- 1.1 This report results from a request by Cotswold Transport Planning's Cheltenham office to provide a road safety opinion on the effects of the increase in traffic on a private lane arising from two additional dwellings.
- 1.2 The lane, which is unnamed is accessed from the A417 London Road in the form of a vehicle crossover of the footway approximately 90 metres west of The Plies and 70 metres east of East End. It currently serves seven dwellings.

Safety Audit Opinion Scope of Reference

2 Road Safety Opinion

Plate 2 – Overhanging Hedgerow

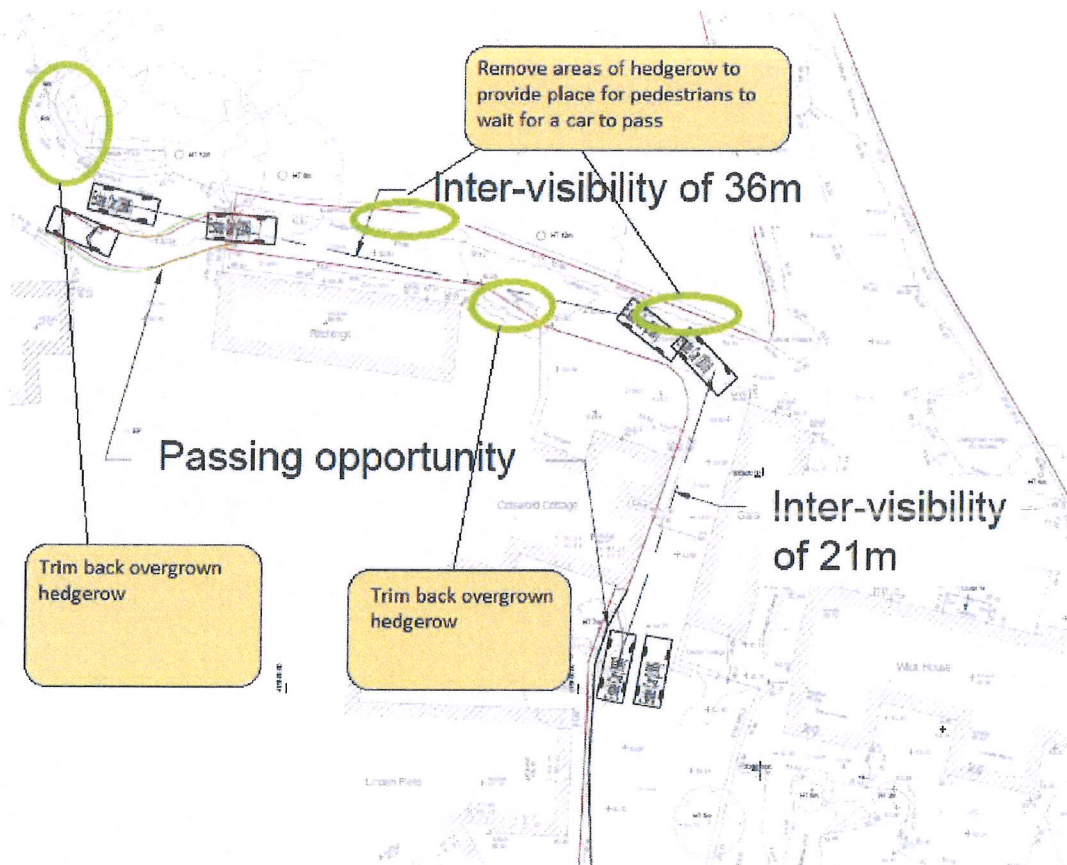
- 2.10 The Audit Team would however recommend that an overgrown hedgerow on the south side of the lane is trimmed to enhance visibility towards the A417 where there is a section of the lane which is wide enough for a car to wait for another car to exit the lane whilst not affecting the free flow of traffic on the A417.
